MEDICINES INSPECTORATE REPORT ON THE CURRENT STATUS AT THE PROTEIN  
FRACTIONATION CENTRE, EDINBURGH AS OF OCTOBER 1 1981

Original					Protein Fractionation Centre EDINBURGH
Date	2-9-81				
Drawn	SK				
By					
		REVISIONS	Date	Name	
SCALE	Title				Drg. No
NTS	PREP FILLING AREA (G.67) -				169

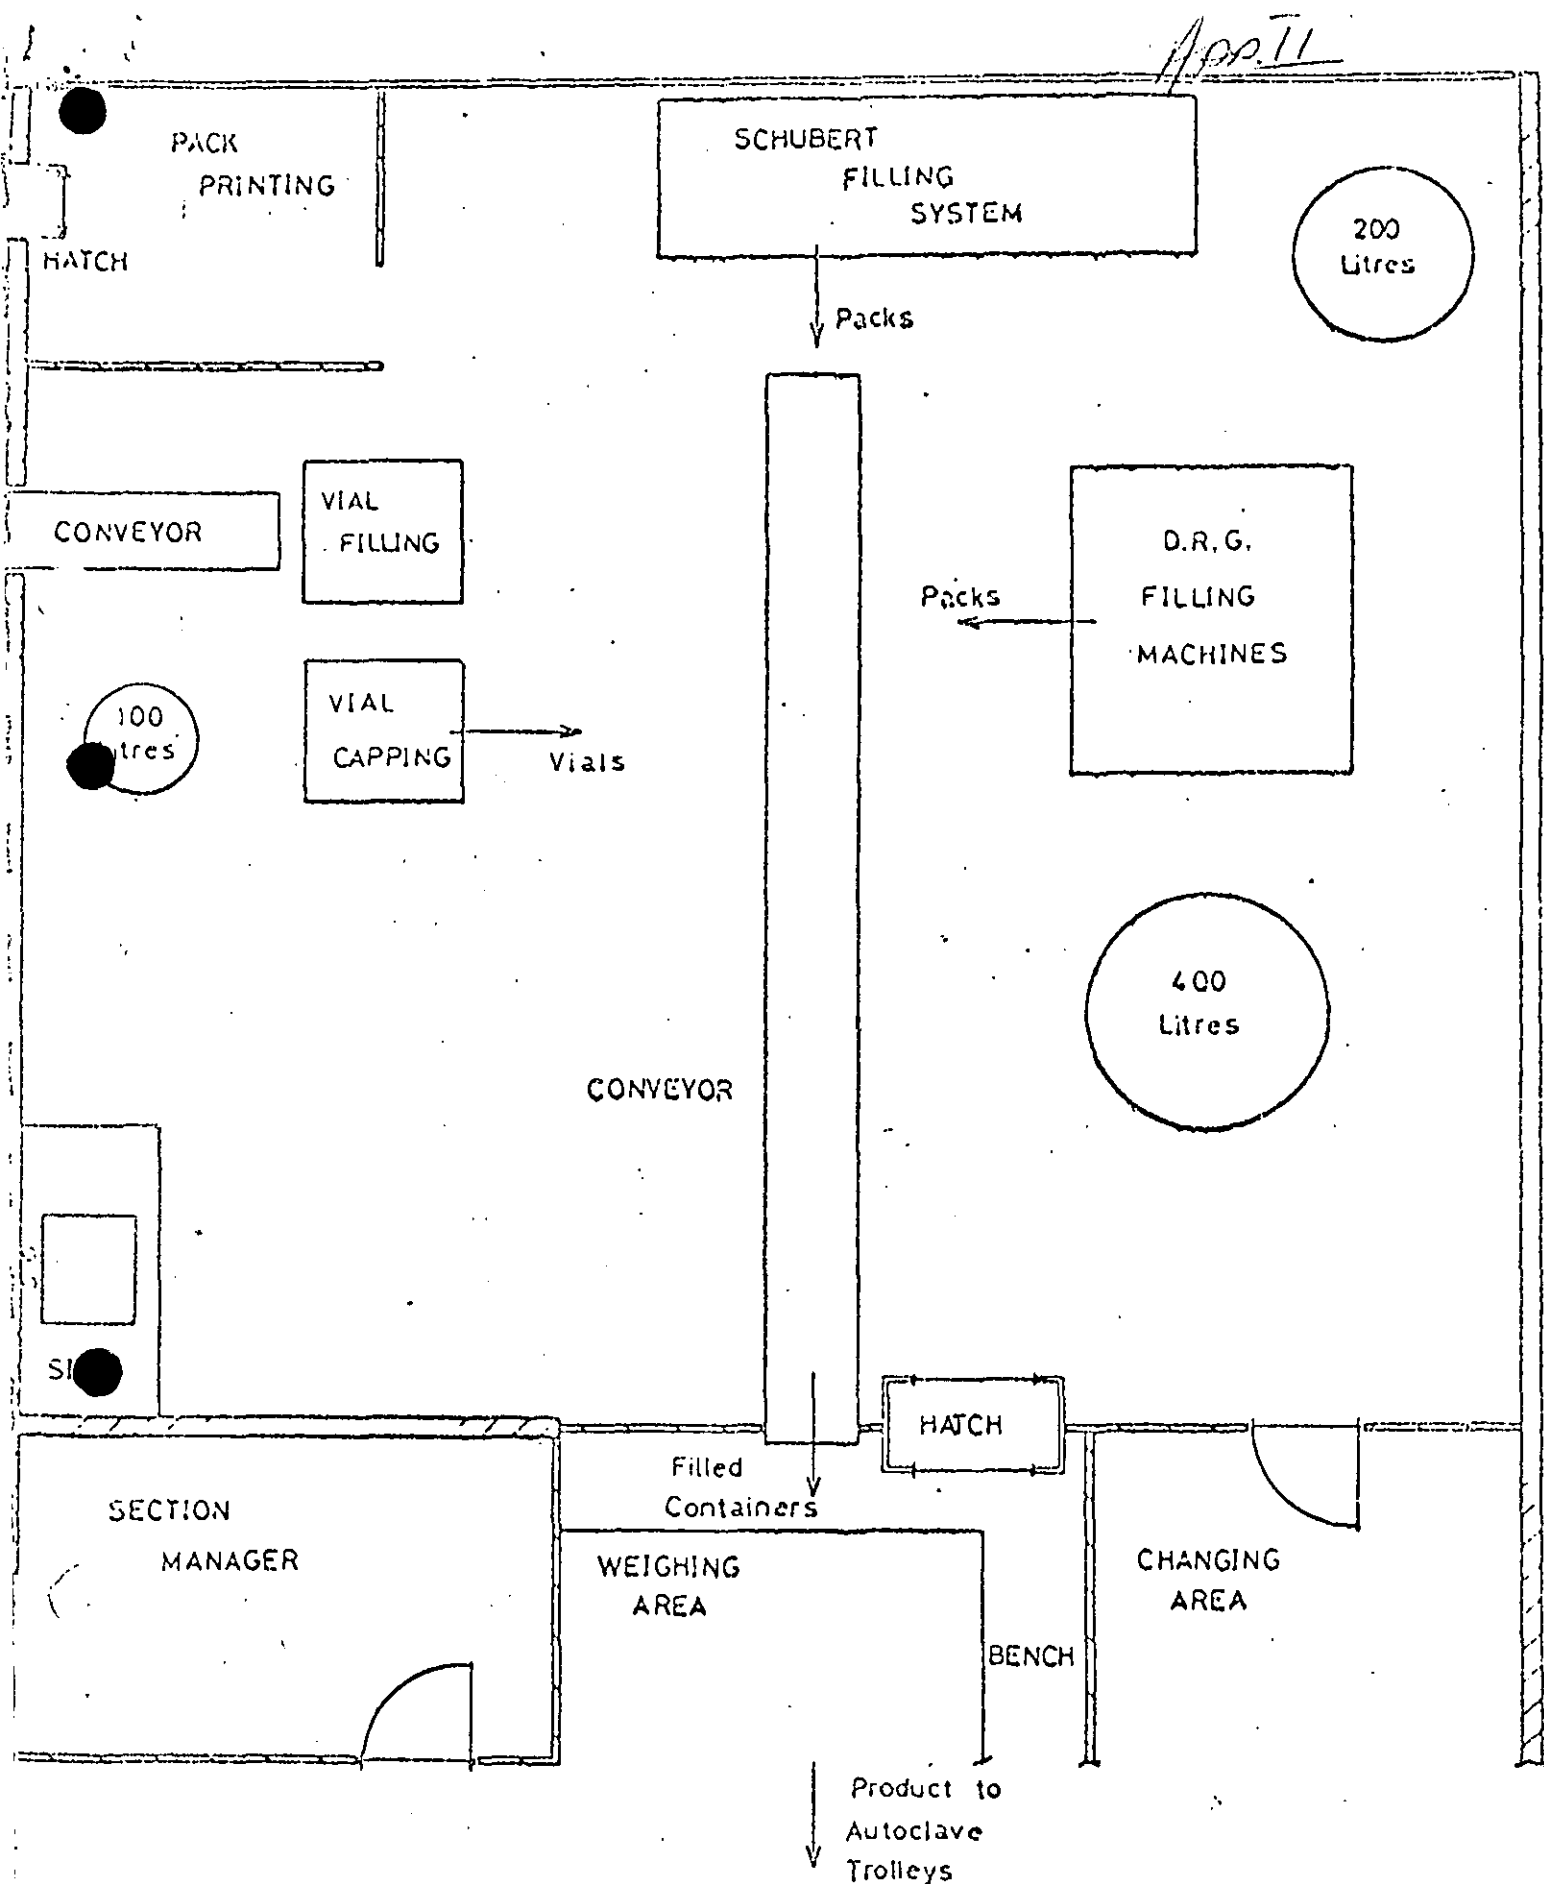
The proposed equipment layout (drawing 169) as detailed in the PFC Response to the Draft Report of 11 and 16 June is acceptable.

The surface finishes of the walls and the crevice between wall and ceilings is still not acceptable.

With the very cramped conditions provided, the implementation of upgrading of room G67 to accommodate bag printing must be a priority (see 3.4).
